Docket Number:	15-AFC-01
Project Title:	Puente Power Project
TN #:	214303
Document Title:	Applicant's Responses to Robert Sarvey's Data Request, Set 2
Description:	N/A
Filer:	Paul Kihm
Organization:	Latham & Watkins LLP
Submitter Role:	Applicant Representative
Submission Date:	10/31/2016 4:39:14 PM
Docketed Date:	10/31/2016

Puente Power Project (P3)
Oxnard, CA

Responses to Robert Sarvey's Data Request Set 2

FIGURE 5-1

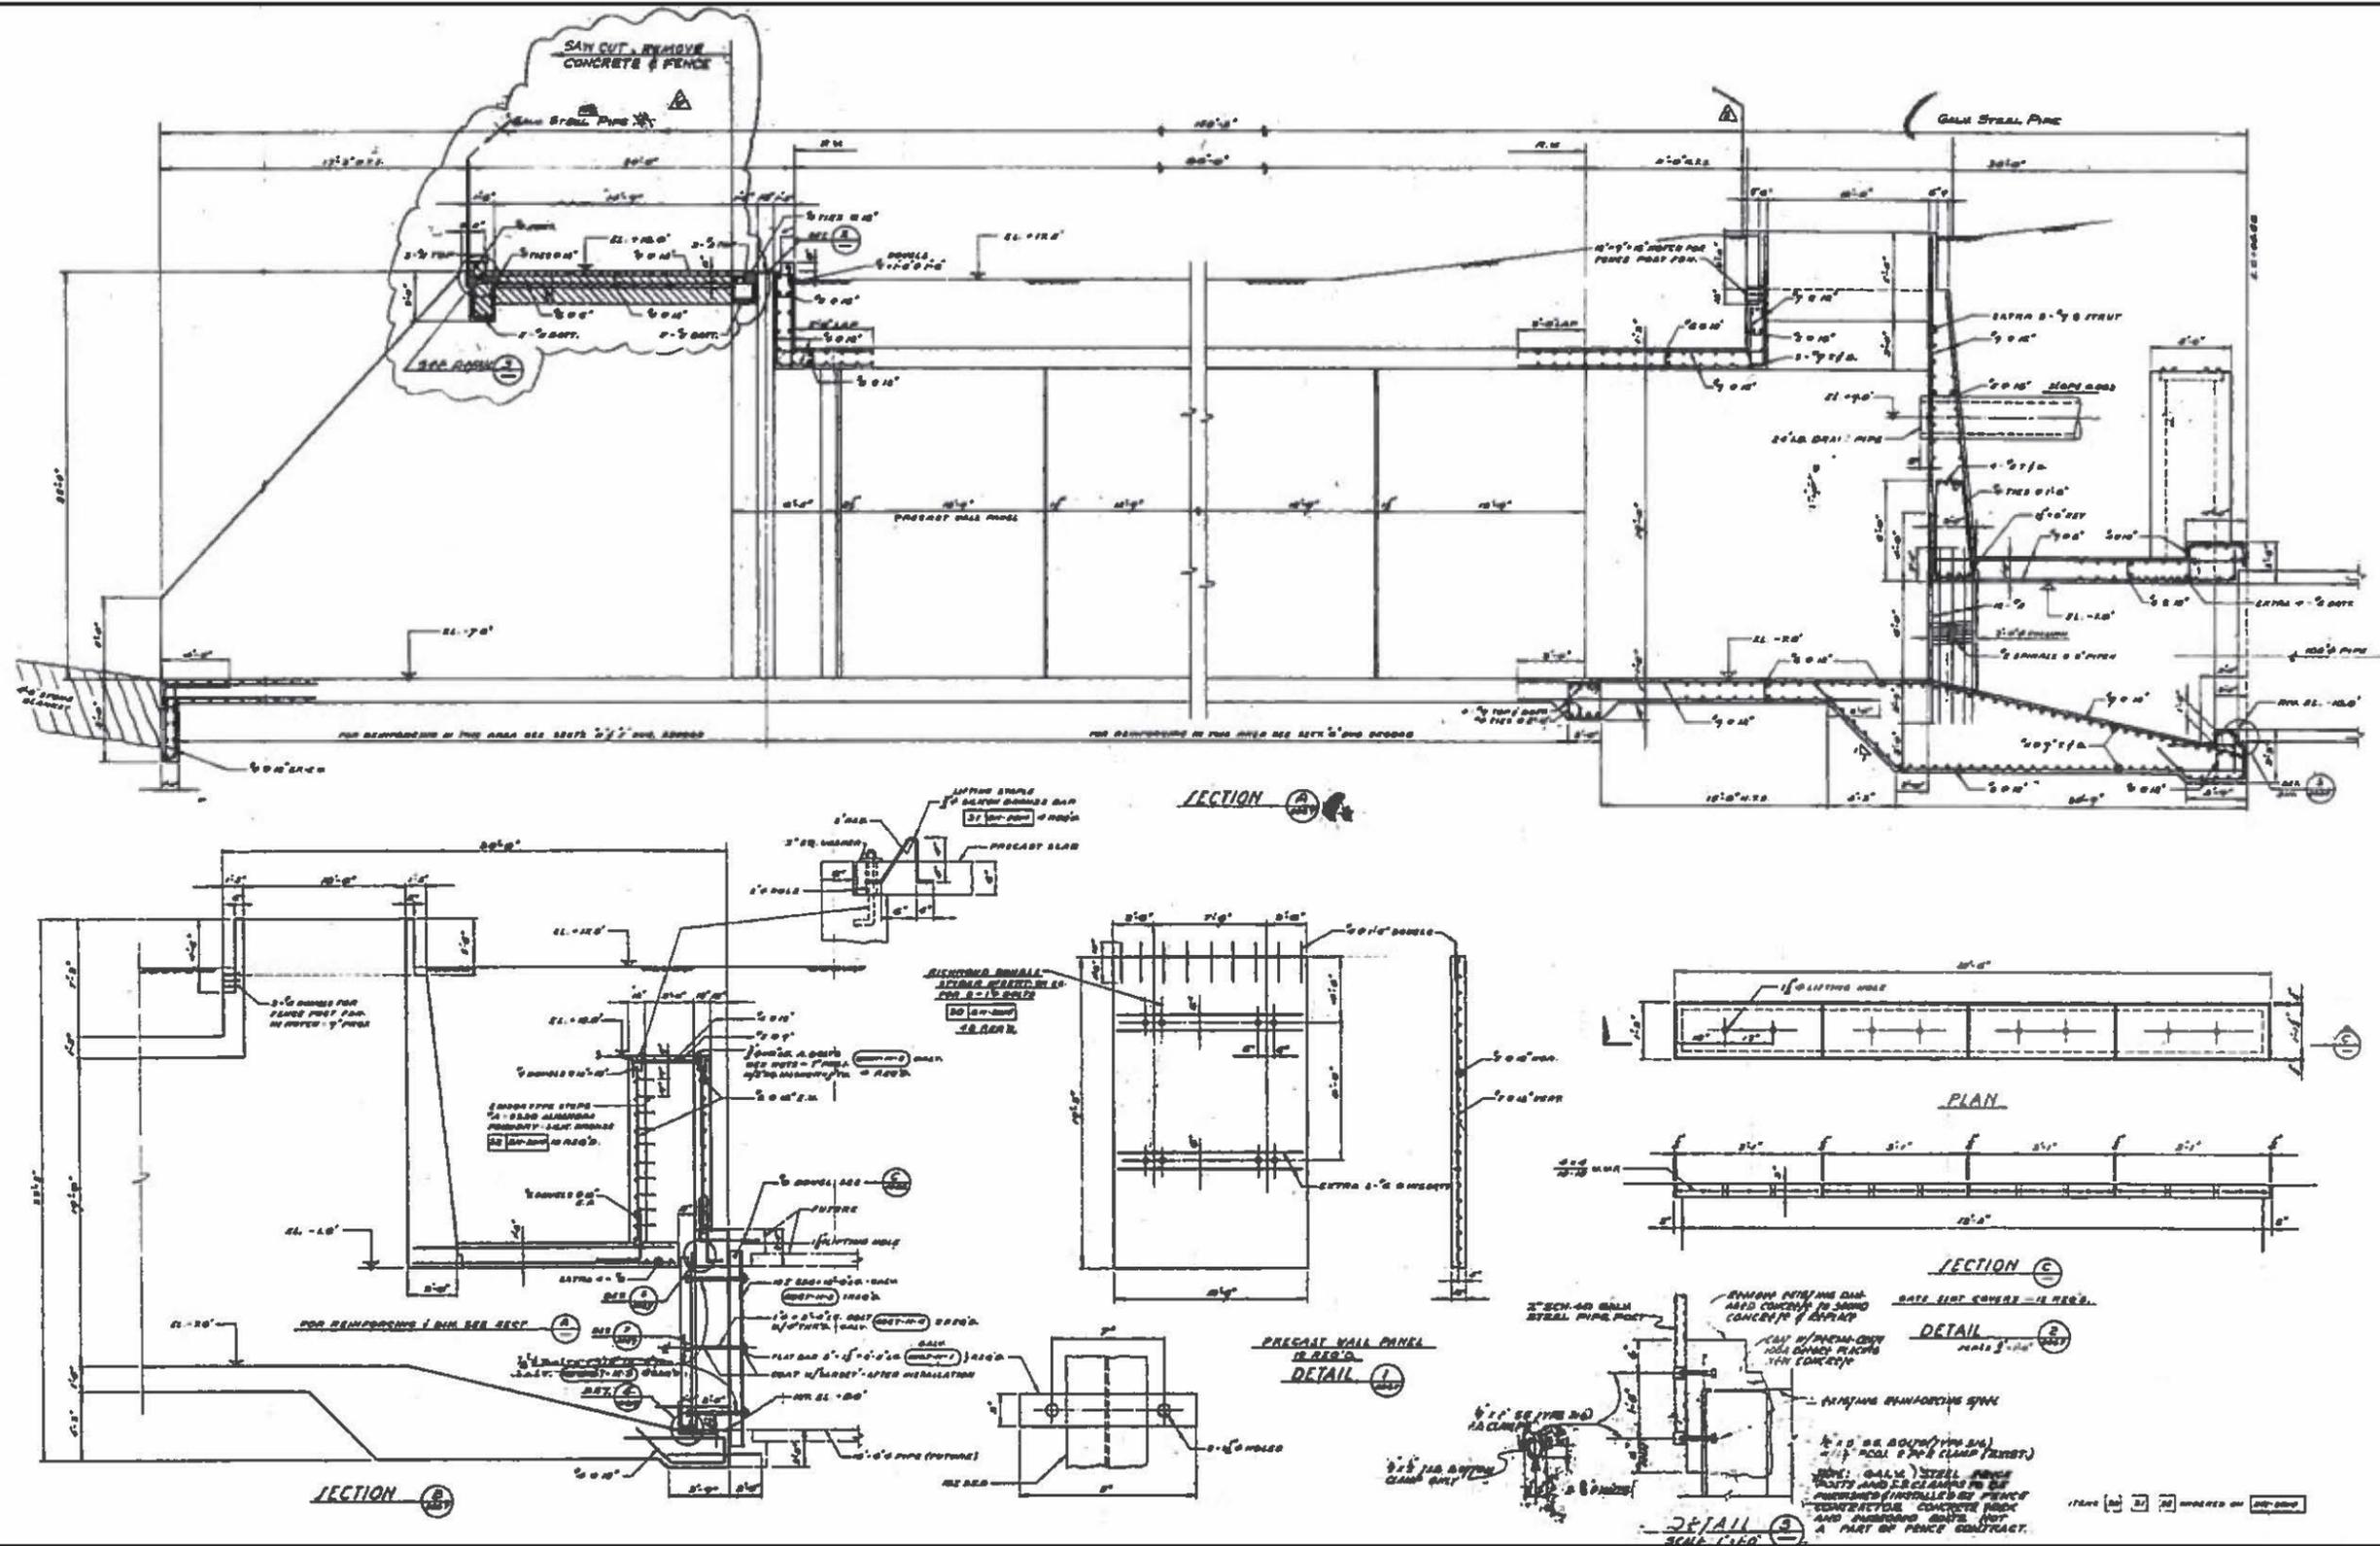
- 5.** *Please provide an as built drawing of the existing outfall.*

See Figures 5-1 and 5-2 for as-built drawings of the existing outfall.
